Shelbourne at Hunterdon  
53 Frontage Road, Suite 110  
Hampton, New Jersey 08827  
Main: 877 627 3772

## **PLANNING REPORT**

### **RE: Woodlands Holding Company, LLC**

Duane Lane (now known as Stone Bridge Court)  
Block 119, Lot 1.51  
Block 120, Lots 1.31, 1.32, 1.41, & 1.42  
Review Letter #2  
Project No. DEP-0207

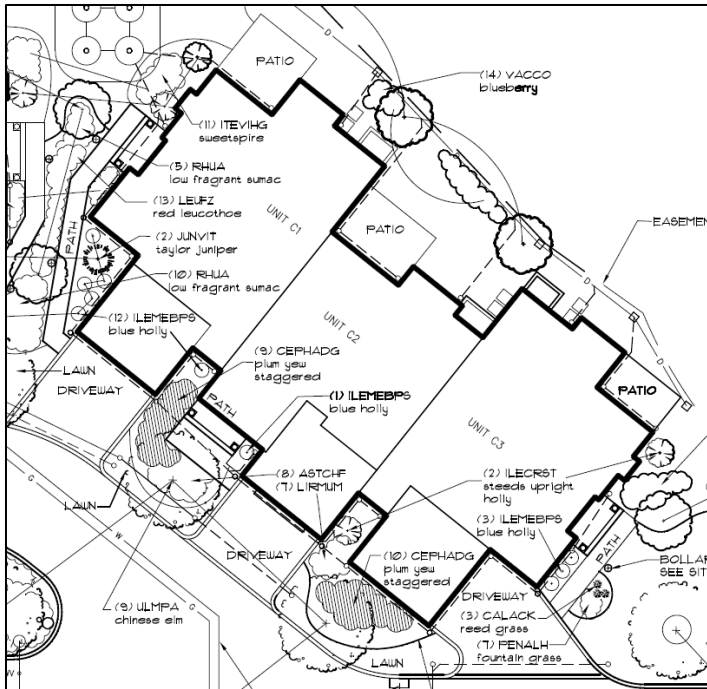
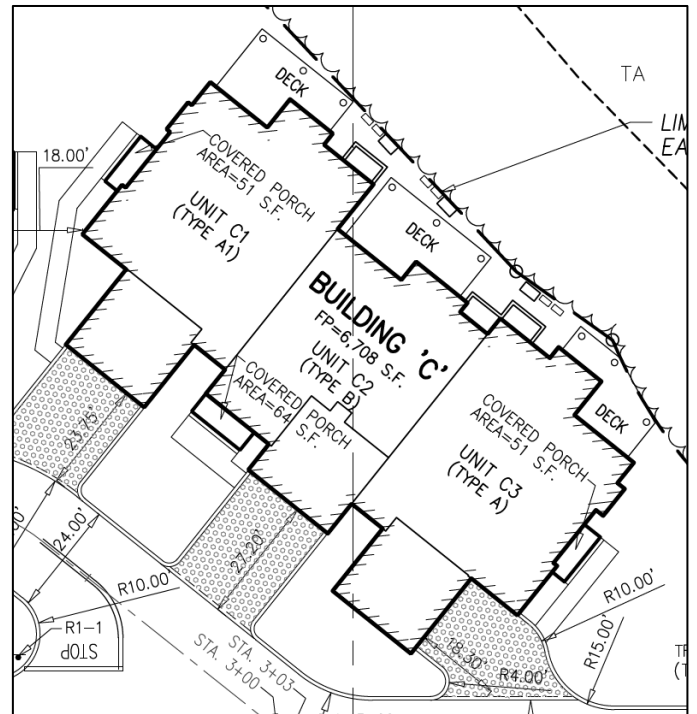
- Eliminate two plants to the rear of Unit A1 to install the generators
- Eliminate at least two plants to the rear of Unit A2 to install the larger deck and generator
- Eliminate shrubs, evergreens, shade trees and perennial beds to install the larger pool patio area
- Eliminate all the proposed landscaping to the rear of Building C (see Figures 1 and 2 below)

Our review of the previously approved Landscape Plans is not exhaustive, but the above illustrates why the Board needs a revised Landscape Plan reflective of the requested changes to determine how many plants will be eliminated as a result of the amendments to the site.

Mr. Hubschman's July 24, 2024 letter indicates that the plans will remain as previously approved and that any addition to the landscaping will be submitted to the Borough's landscape architect prior to a CO being issued.

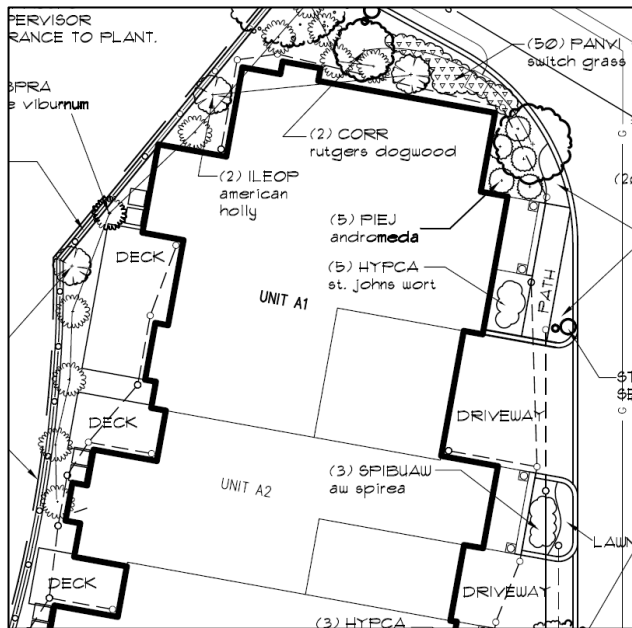
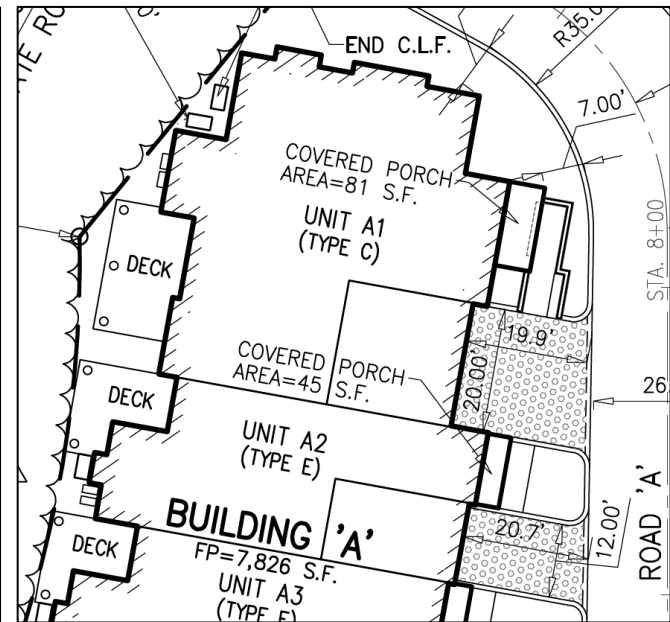
23. The shape of the buildings and their proximity to the Conservation Easement appears to have changed since the April 15, 2021 Landscape Plans. For example, as illustrated by the comparison on page 6, Building C now appears closer to the Conservation Easement. As shown in the comparison below, the shape of Unit A1 has changed as well as its proximity to the Conservation Easement. Testimony shall be provided on how these changes occurred and if they were approved as field changes.
